## Review of 2018 Bedrock Investigation Documents for the Coakley Landfill

Thomas P. Ballestero

6 June 2018

The following documents were reviewed to assess whether the EPA letter of May 1, 2018 requires something more by way of bedrock investigation in order to detect flow of contaminants from the Coakley Landfill going to the south or the east, than is being proposed by the Coakley Landfill Group's Expert (CES), and if EPA's letter does not require something more, an opinion is offered on why should EPA so require.

Figure 6. Lateral Distribution of PFOA and PFOS in Overburden from the CES 2017 Annual Summary Report

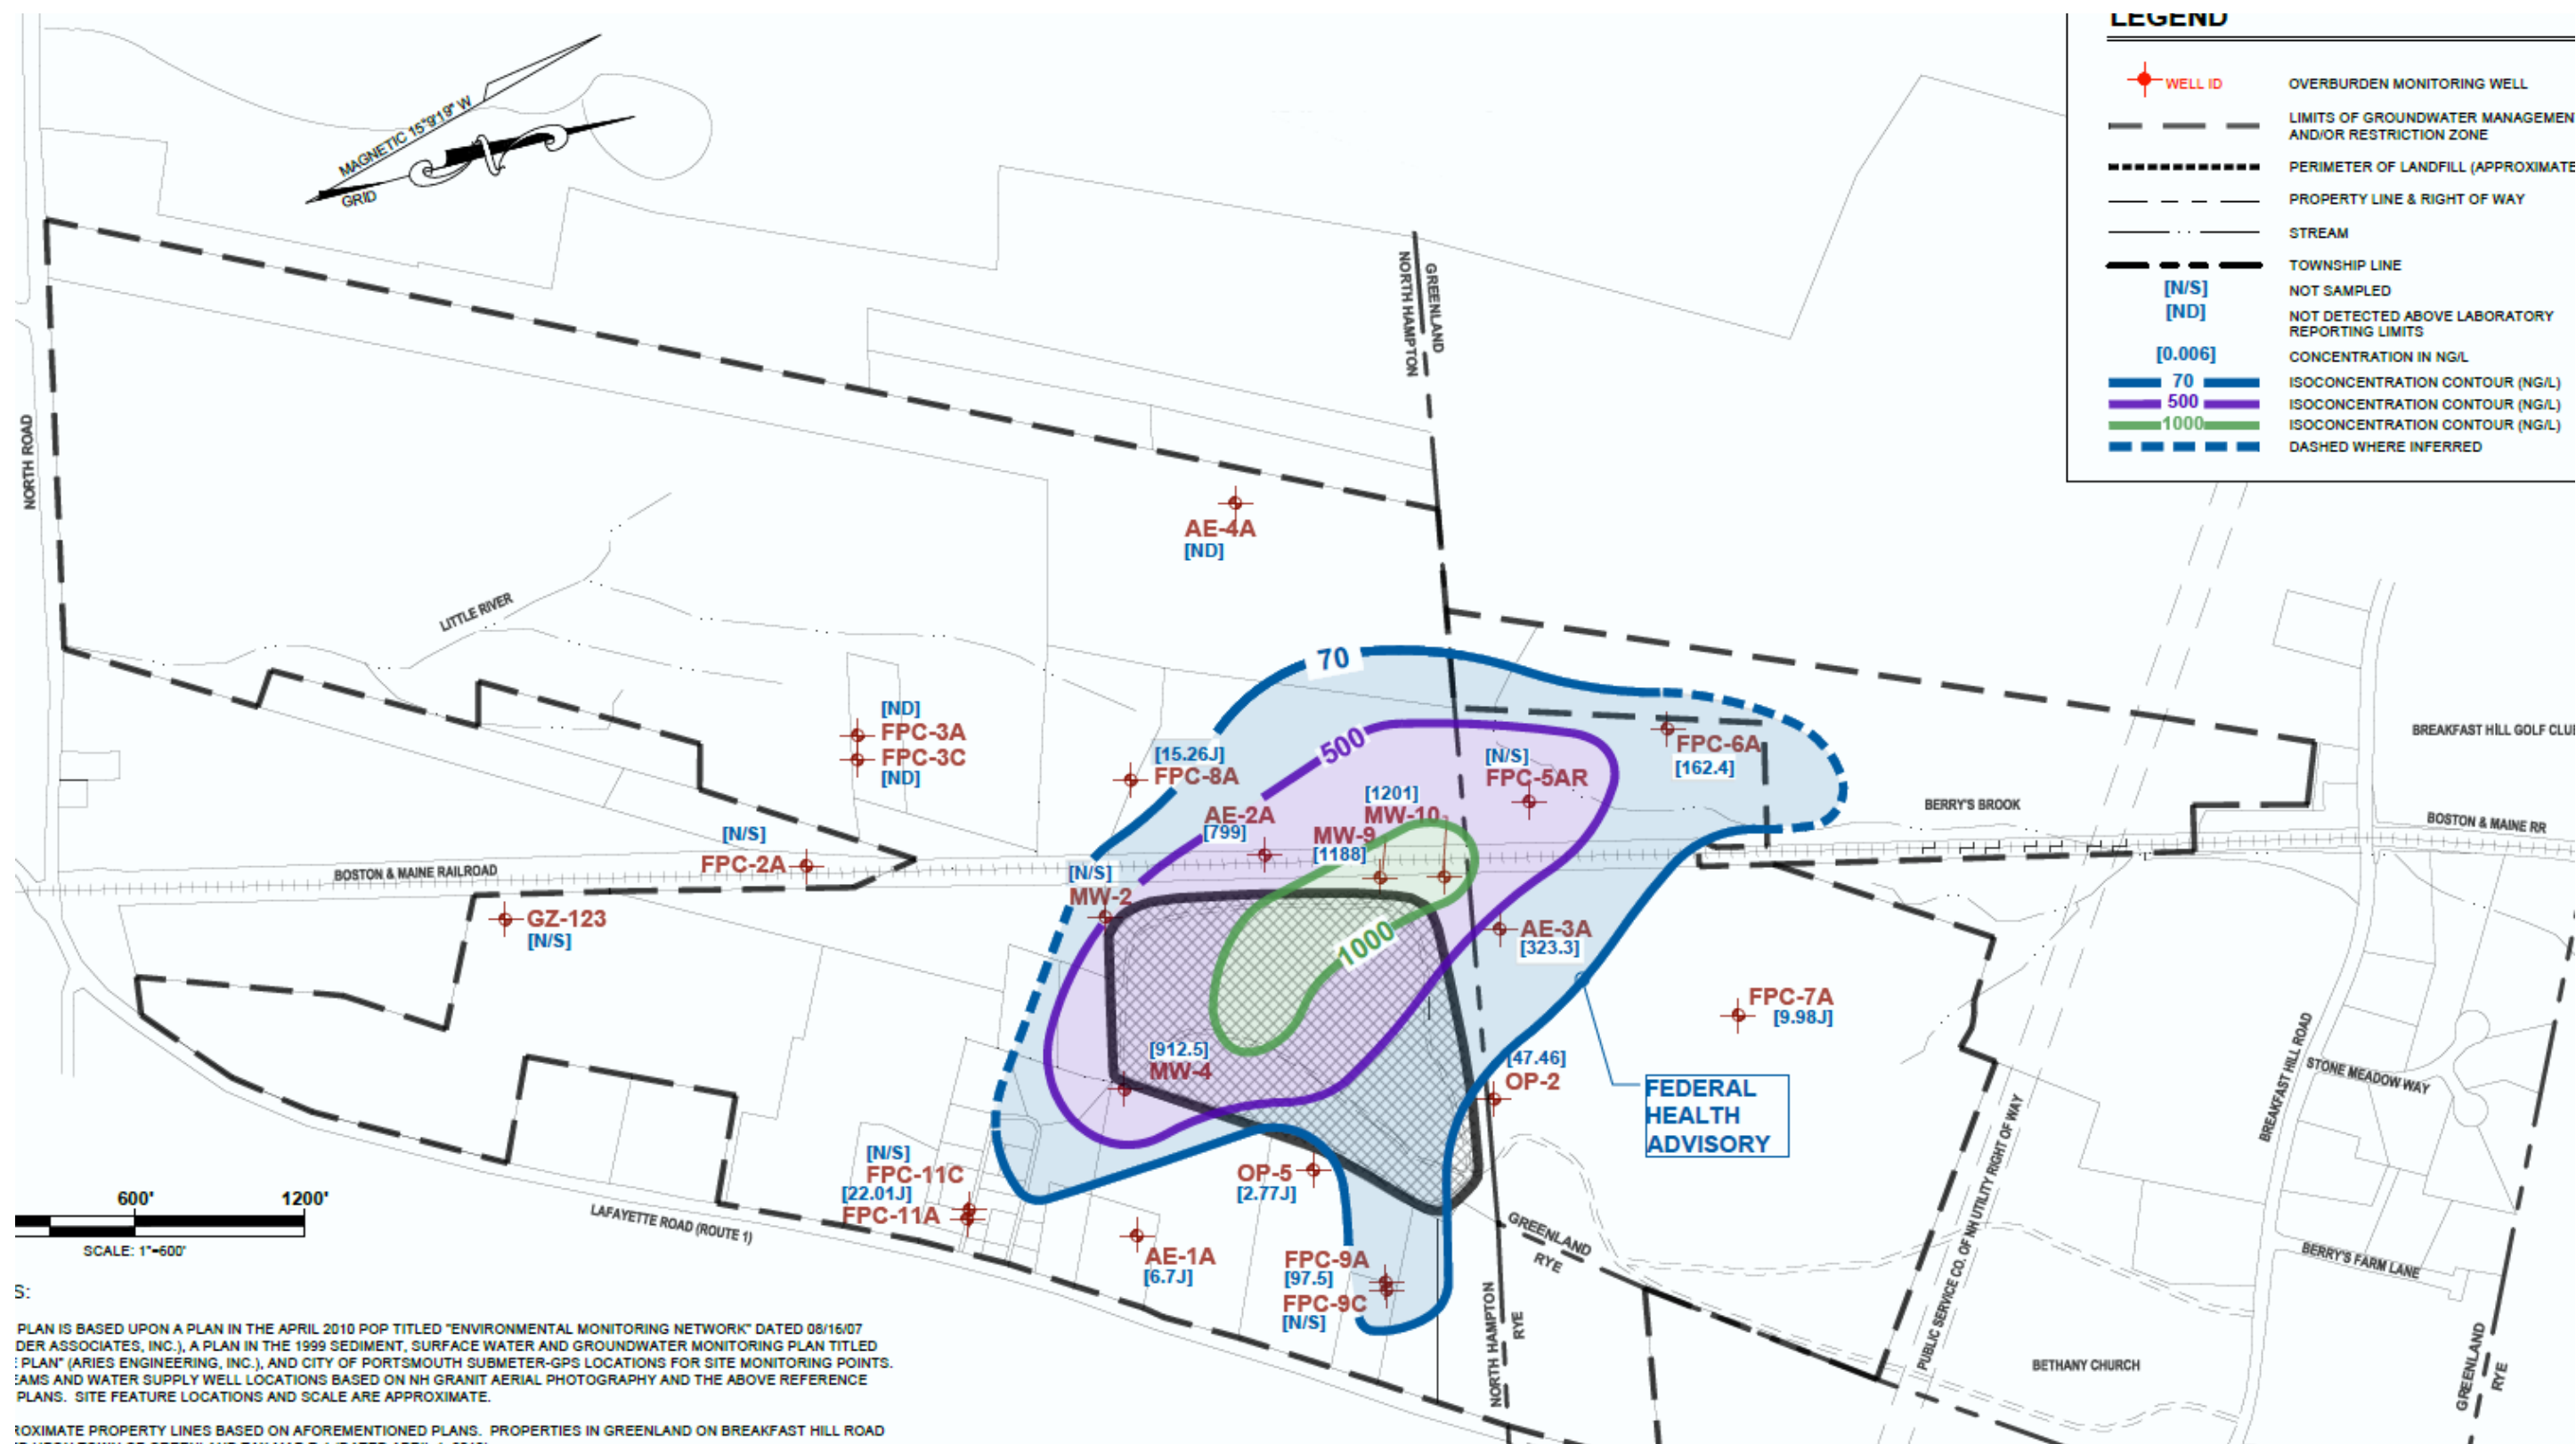
Figures 6 and 7 here, taken from the CES 2017 Annual Summary Report, succinctly illustrate the differences between overburden and shallow bedrock plumes for PFOA and PFOS, with the bedrock plume demonstrating that it moved west then turned south. I commented on this exact issue at the public meeting in North Hampton last November, especially the westward/southward plume movement.

Figure 7. Lateral Distribution of PFOA and PFOS in Bedrock from the CES 2017 Annual Summary Report

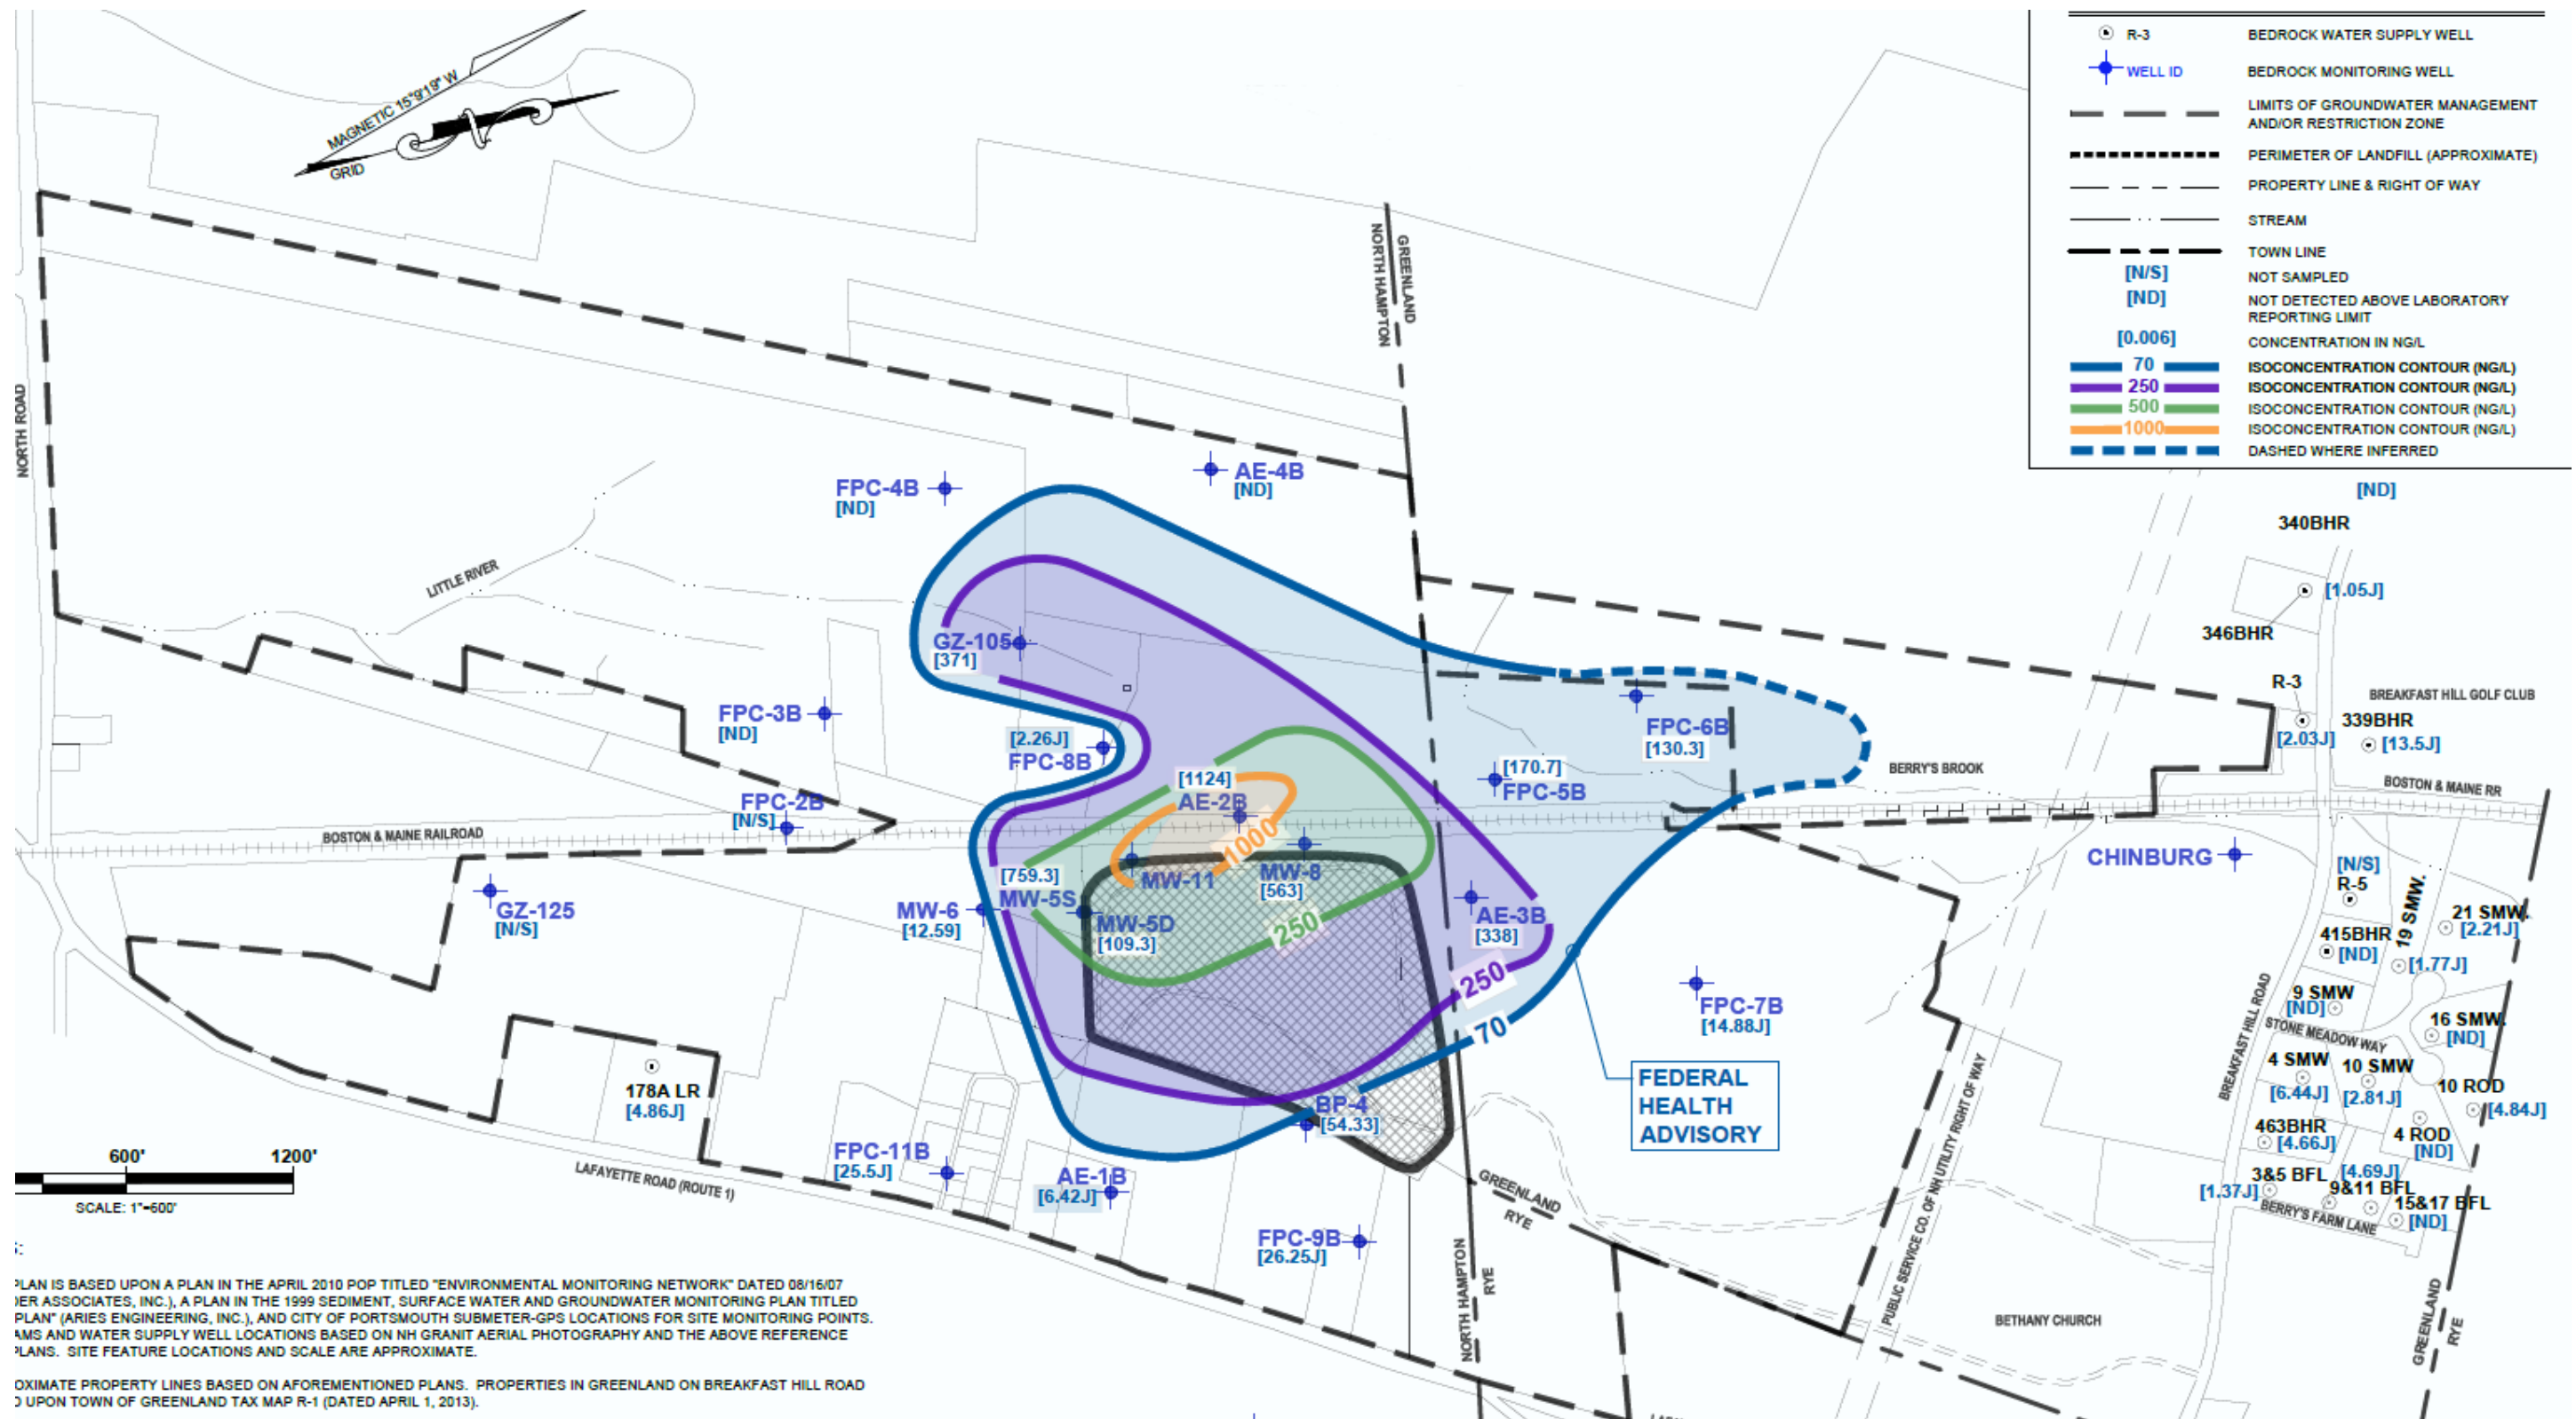
Figure 7 here displays the bedrock groundwater PFOS/PFOA contours. The contours stop at 70 ng/L, but concentrations of concern are further eastward. If a 20 ng/L contour were to be drawn, it would give a much more realistic understanding of plume extent and movement.

Figure 8. Relative locations of Coakley landfill to drinking water wells

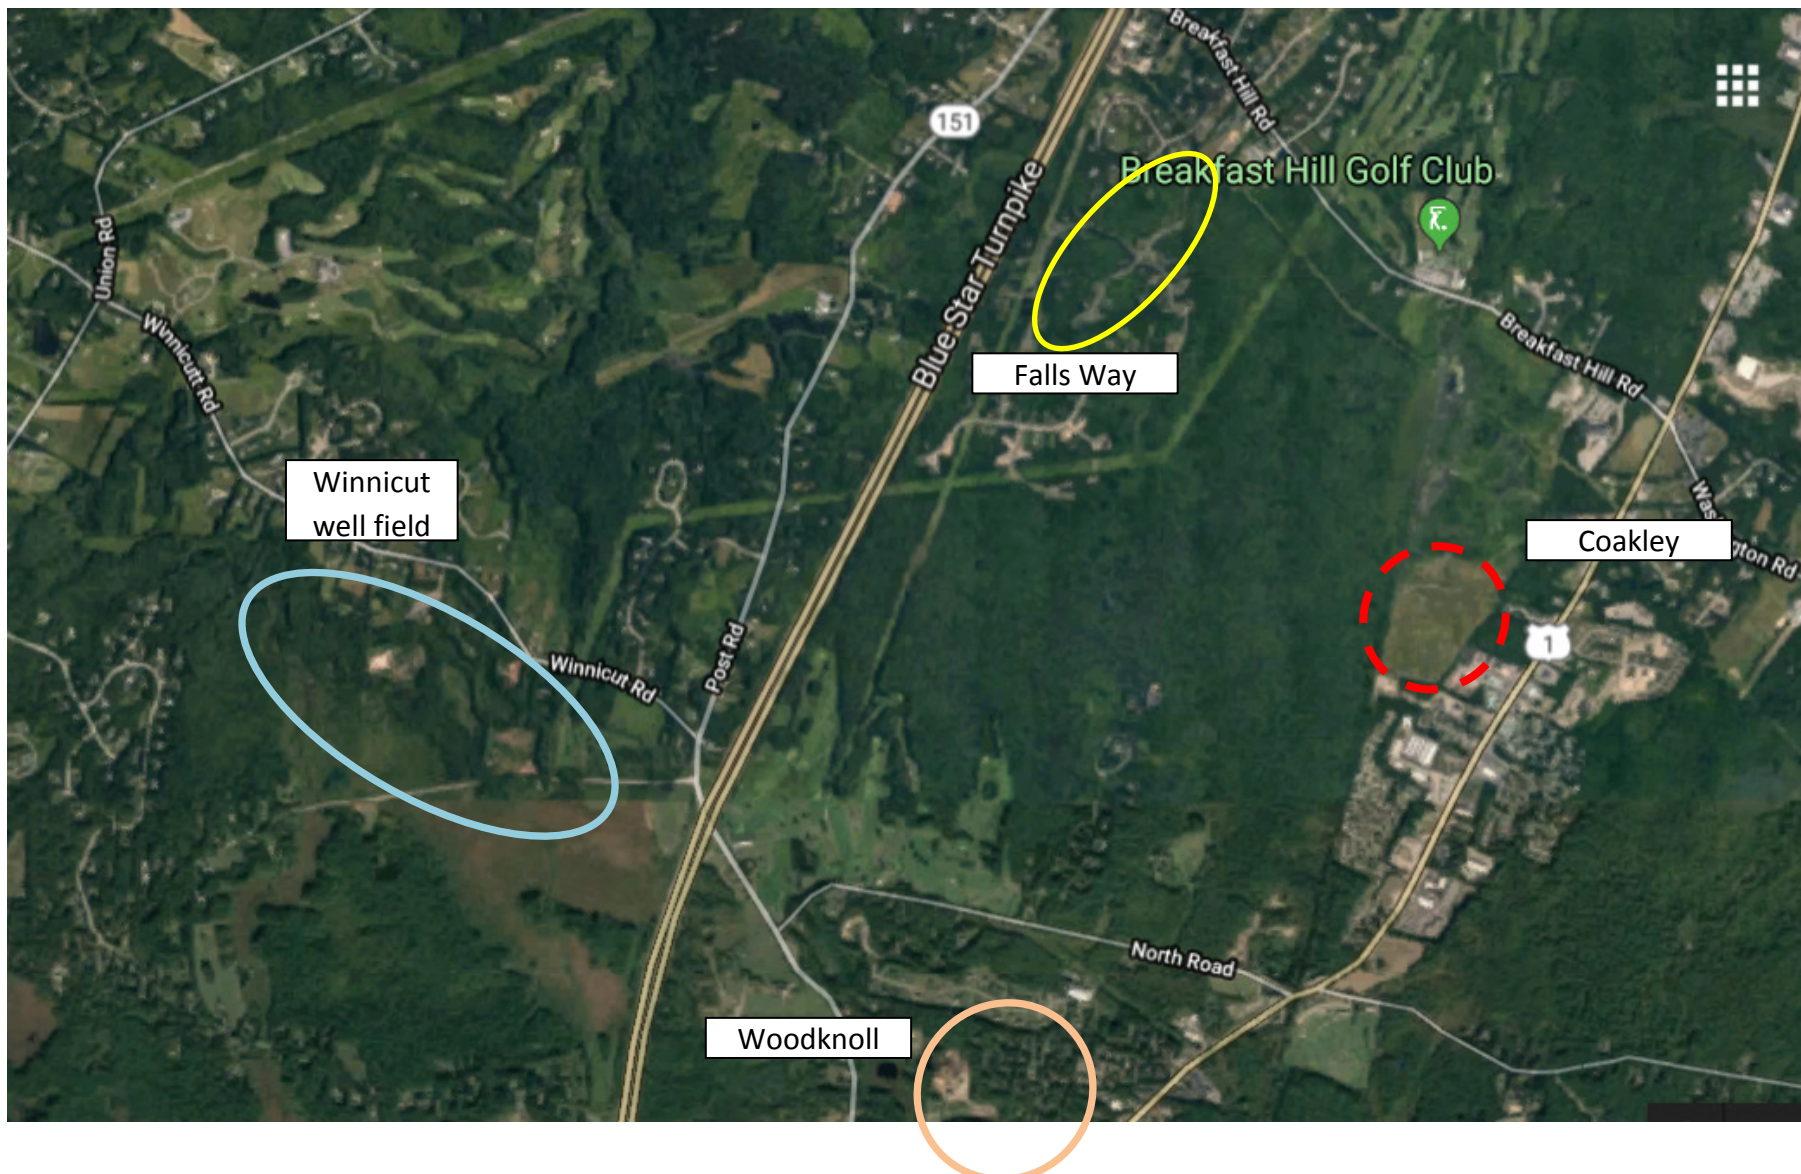
Figure 8 presents the relative locations of the Coakley landfill to some domestic water wells. The CLG seems to have focused some attention on Falls Way, which according to their own conceptual hydrogeologic model, should be out of harm's way. However, given the broader concerns of public health and groundwater supply, concern for further bedrock groundwater investigations should be directed at both the Aquarion Water Company Winnicut well field to the

west (shown in Figure 8 here) as well as the Woodknoll Drive subdivision in which PFOA and PFOS have been detected in homeowner wells. Given the decades that have transpired, the bedrock plume trajectory, the intricate movement of groundwater through fractured rock systems, the very high water solubility for PFOA/PFOS, the limited degradation of PFOA/PFOS, and the regional conceptual hydrogeologic model... it is certainly plausible that the Woodknoll subdivision is a location where the Coakley plume has moved. Furthermore, when reflecting on Aquarion's wellhead protection area map (Figure 9 here) for its Mill Road well field in Hampton, the Woodknoll Drive subdivision is within this wellhead protection area.
